FIELD SERVICE BULLETIN

FSB Number: LVCCFSB2006-162 (Rev. A)
Author: Tony Bryan
Date: April 24, 2006
Total No. of Pages: 3
Subject: GSM PEBL U6 – Main Display Lens Lift
Model Affected: GSM PEBL U6
Level of Repair: 2

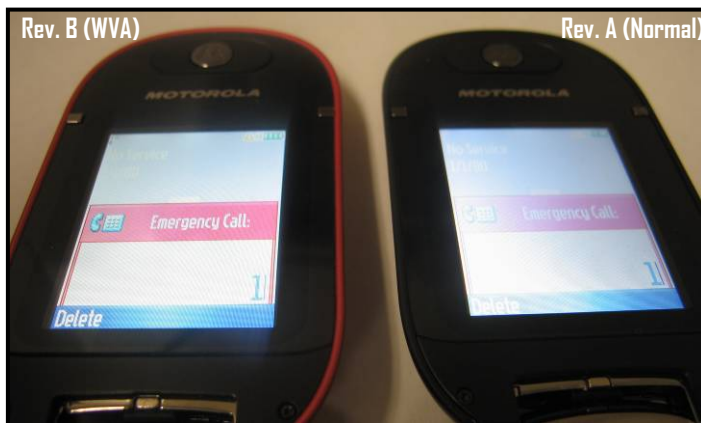
Revision B display contains wide viewing angle polarizer.
Red image displayed on Rev B is more vibrant and easily viewed.
Red image displayed on Rev A is washed out.

1. Power up unit (no SIM required).
2. Press #1 key (initiates emergency mode).
3. Rotate unit away at 45-degree angle from user.
4. View red area of "Emergency Call" window.
